**CENTER FOR DRUG EVALUATION AND  
RESEARCH**

**761180Orig1s000**

**OTHER REVIEW(S)**

Date: December 9, 2021  
Reviewer: Catherine Lerro, PhD, MPH  
Division of Epidemiology I  
Deputy Director: CAPT. Sukhminder K. Sandhu, PhD, MPH, MS  
Division of Epidemiology I  
Subject: ARIA Sufficiency Memo for Pregnancy Safety Concerns  
Drug Name: Tralokinumab (ADBRY)  
Application Type/Number: BLA 761180 / IND 123797  
Sponsor: LEO Pharma A/S  
OSE RCM #: 2021-198

**Figure 1** Schematic drawing of the APFS

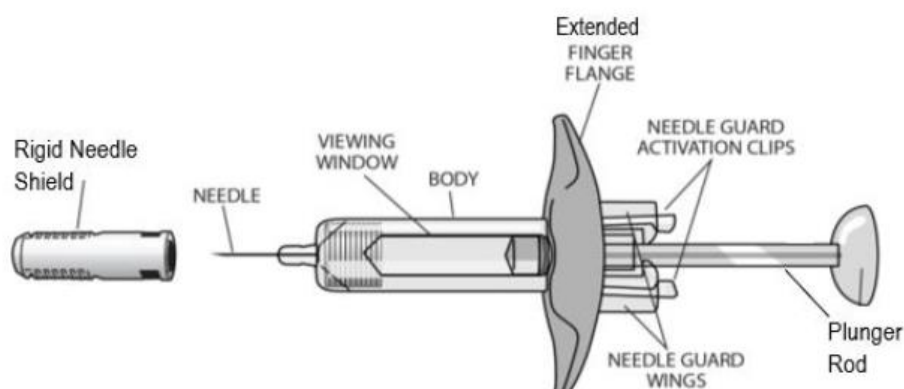
Needle safety performance needs to be tested on the final finished combination product because the prefilled syringe, design differences between your final finished combination product and currently marketed products, combination product manufacturing and preconditioning would impact the performance and reliability. Failure of the needle safety device to perform adequately may result in serious risks (accidental contaminated needle sticks). Provide testing demonstrating that your final finished combination product needle safety performance (needle safety activation and lockout) can meet a confidence and reliability of 95%/99% after aging of the device to the proposed shelf-life, drop testing and simulated shipping per ASTM 4169-16 *Standard Practice for Performance Testing of Shipping Containers and Systems* sequentially.

The reliability and sample size is not acceptable. Please analyze the data assuming confidence interval of 95% with 99% reliability. Please provide the sample size to demonstrate the confidence interval and reliability required.

An IR was issued December 14, 2020 in CR#3. The response was not adequate. The sponsor provided documentation of the testing of the (b) (4) which was approved through 510(K). This testing is provided, however, the testing does not appear to include any testing with aging of the device (Shelf-Life), dropping of the device, and simulated shipping. It is not clear if the testing is the final manufactured design of the proposed device. Needle safety performance needs to be tested on the final finished combination product because the prefilled syringe, combination product manufacturing and preconditioning may impact the performance.

**Figure 1** Schematic drawing of the APFS

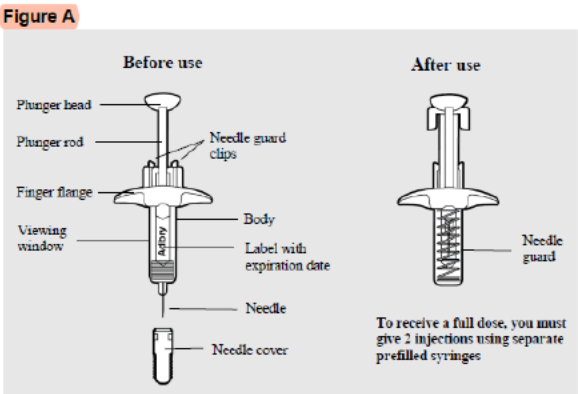
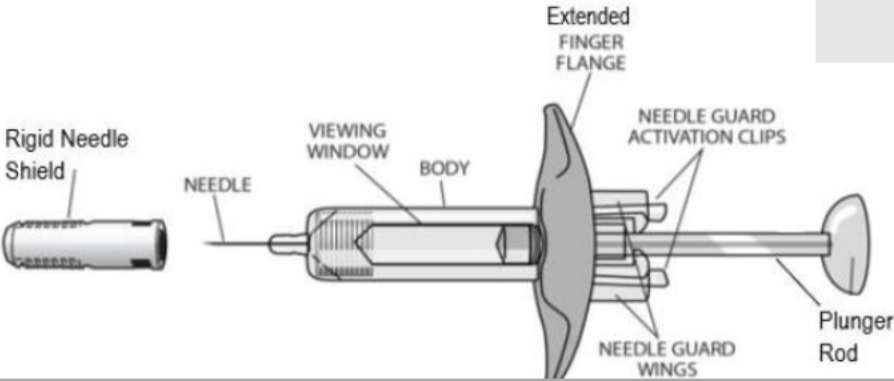
Needle safety performance needs to be tested on the final finished combination product because the prefilled syringe, design differences between your final finished combination product and currently marketed products, combination product manufacturing and preconditioning would impact the performance and reliability. Failure of the needle safety device to perform adequately may result in serious risks (accidental contaminated needle sticks). Provide testing demonstrating that your final finished combination product needle safety performance (needle safety activation and lockout) can meet a confidence and reliability of 95%/99% after aging of the device to the proposed shelf-life, drop testing and simulated shipping per ASTM 4169-16 *Standard Practice for Performance Testing of Shipping Containers and Systems* sequentially.

The reliability and sample size is not acceptable. Please analyze the data assuming confidence interval of 95% with 99% reliability. Please provide the sample size to demonstrate the confidence interval and reliability required.

An IR was issued December 14, 2020 in CR#3. The response was not adequate. The sponsor provided documentation of the testing of the (b) (4) which was approved through 510(K). This testing is provided, however, the testing does not appear to include any testing with aging of the device (Shelf-Life), dropping of the device, and simulated shipping. It is not clear if the testing is the final manufactured design of the proposed device. Needle safety performance needs to be tested on the final finished combination product because the prefilled syringe, combination product manufacturing and preconditioning may impact the performance.

**Figure 1**                      **Schematic drawing of the APFS**

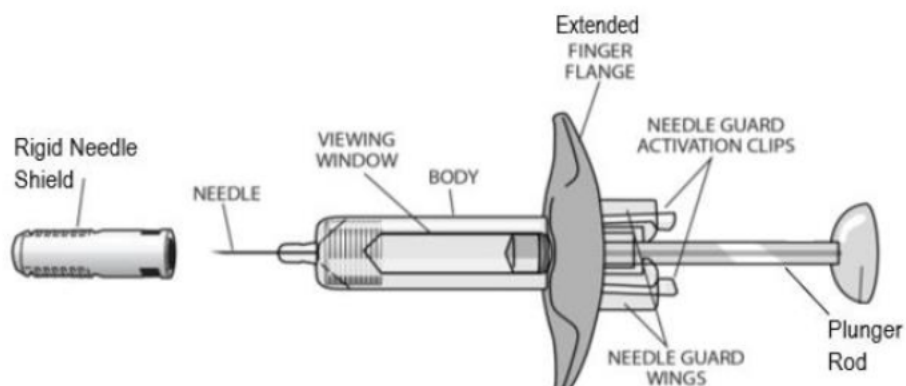
The reliability and sample size is not acceptable. Please analyze the data assuming confidence interval of 95% with 99% reliability. Please provide the sample size to demonstrate the confidence interval and reliability required.

An IR was issued December 14, 2020 in CR#3. The response was not adequate. The sponsor provided documentation of the testing of the (b) (4) which was approved through 510(K). This testing is provided, however, the testing does not appear to include any testing with aging of the device (Shelf-Life), dropping of the device, and simulated shipping. It is not clear if the testing is the final manufactured design of the proposed device. Needle safety performance needs to be tested on the final finished combination product because the prefilled syringe, combination product manufacturing and preconditioning may impact the performance.
